APPLICATION AND PRELIMINARY PLAT CHECKLIST

Name of Proposed Subdivision Rockwall Towne Centre
Name of Subdivider Dunning Development Company
Address 8235 Douglas Ave., Suite 816, Dallas, TX 75225 Phone 214/528-1905
Owner of Record Rockwall Village LTD
Address 8235 Douglas Ave., Suite 816, Dallas, TX 75225 Phone 214/528-1905
Name of Land Planner/Surveyor/Engineer Wier & Associates
Address 3908 S. Freeway, Ft. Worth, TX 76110 Phone 817/926-0212
Total Acreage 21.95 AC Current Zoning Commercial
No. of Lots/Units 6 Signed [Signature]

RE: Rockwall Towne Center

SUBJECT: Rockwall Towne Center Site Plan
DATE: 8/31/84

PRELIMINARY PLAT ROCKWALL TOWNE CENTRE

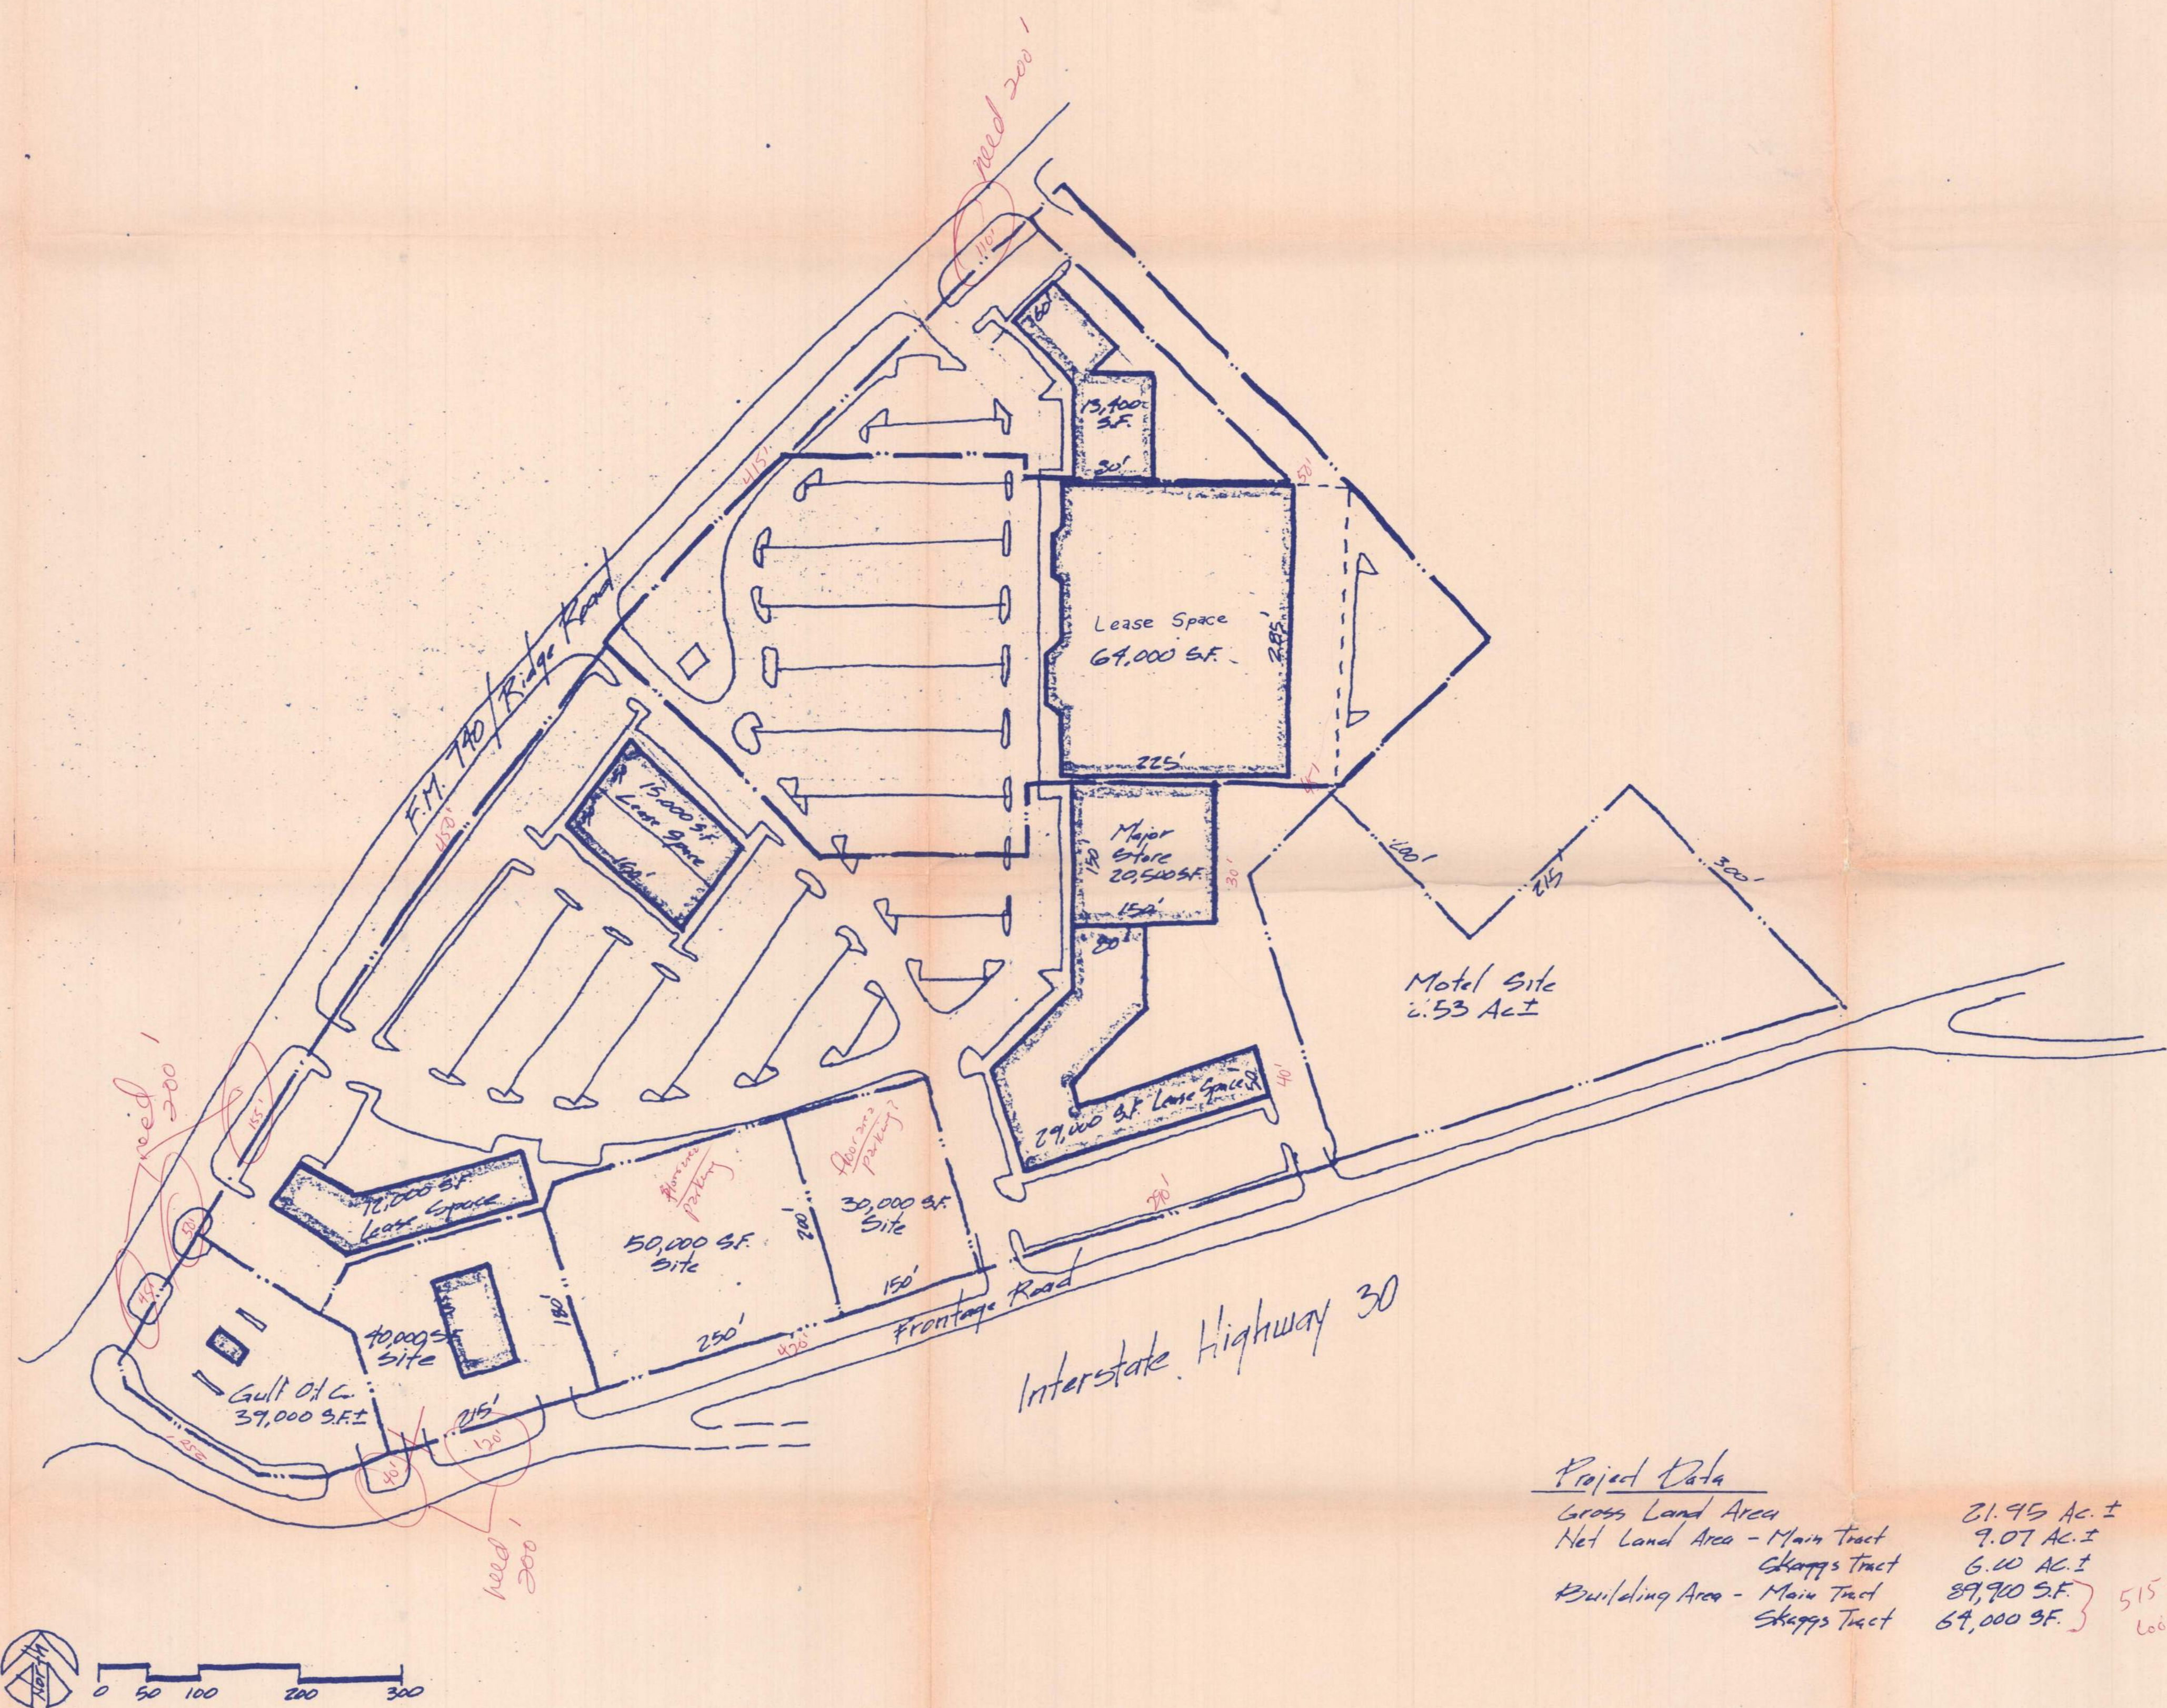
POW on 740?

- ① Landscaping - amount, location
- ② width of entrances
- ③ scaled drawing
- ④ no. parking spaces
- ⑤ height structures
- ⑥ Signs

**I 30 & RIDGE ROAD SHOPPING CENTER
ROCKWALL, TEXAS
DUNNING DEVELOPMENT**

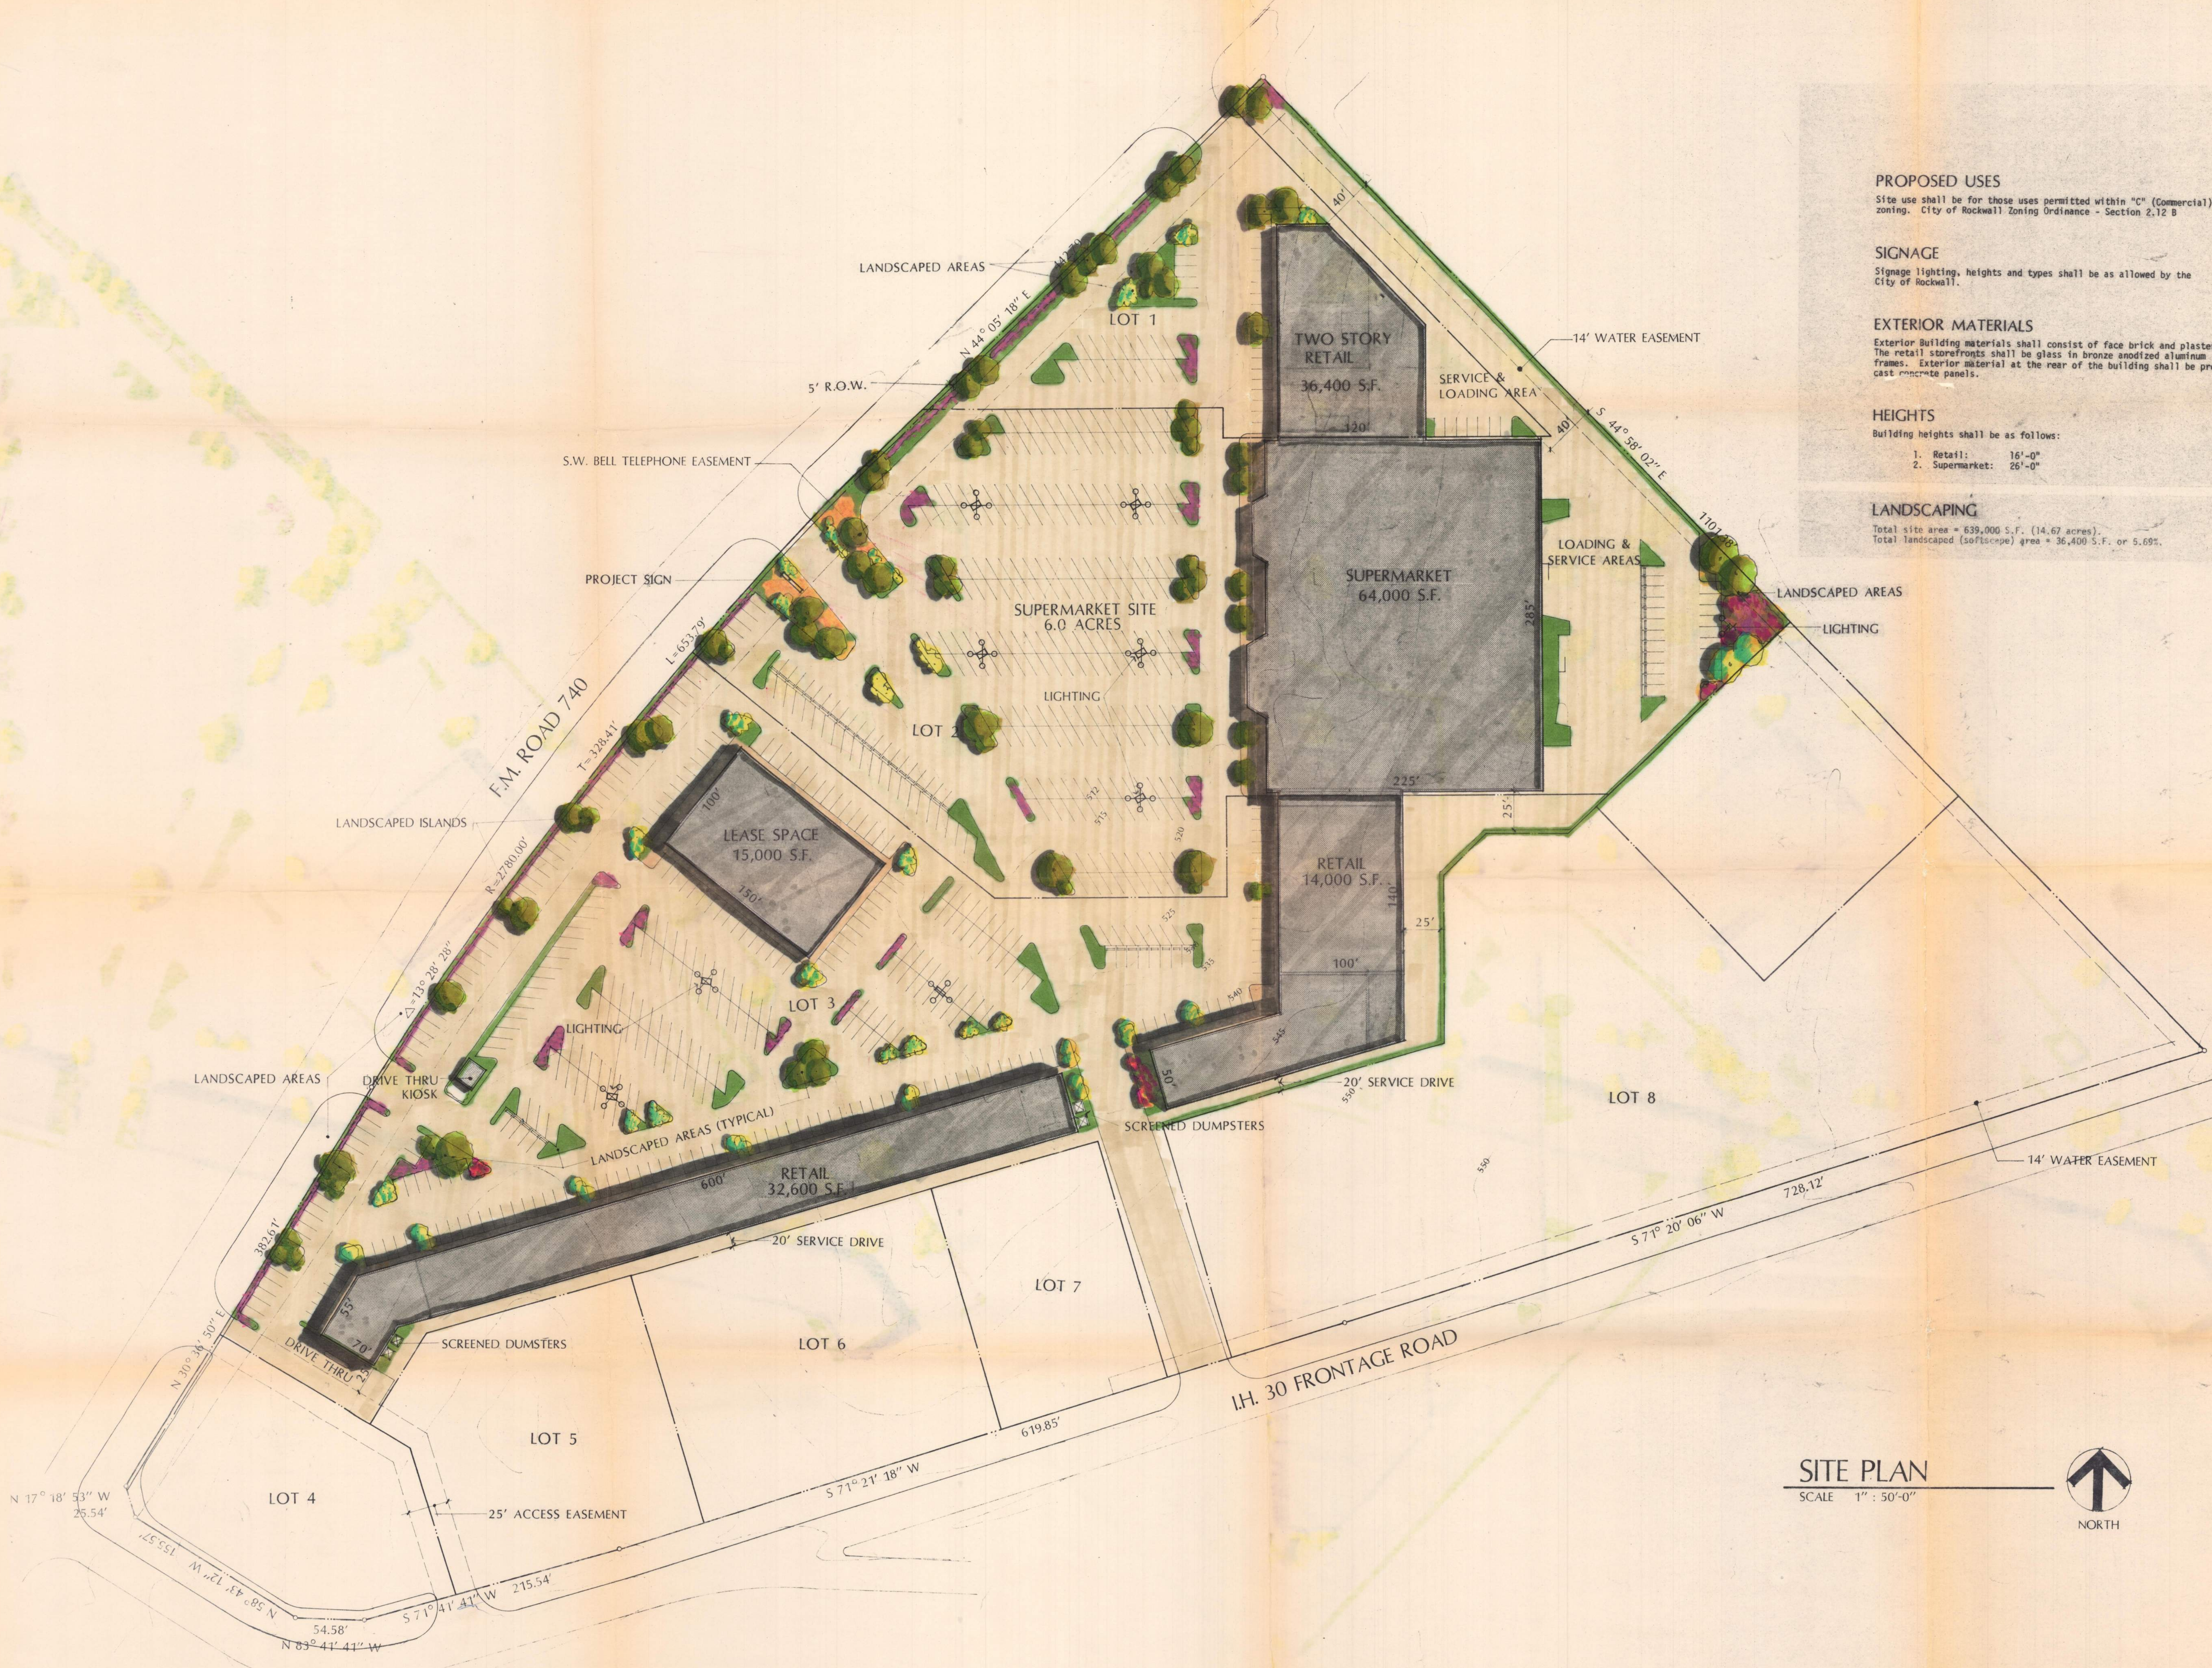
1. Calculate square footage in landscaping.
2. Provide more landscaping along FM-740 frontage in groups.
3. Where will dumpster be for 32,600 sq. ft. building?
4. Two northernmost entrances on FM-740 are too close together - separation must be 200 ft.
5. Final plat should show right-of-way on FM-740.

1. Detail paving width of drives behind retail buildings toward I-30 for service and fire protection
2. Label areas toward I-30 which will be site planned separately and are not, therefore, considered in landscaping and parking calculations so future developer will know site plan must be submitted and area counted as landscaping now will not later be paved.
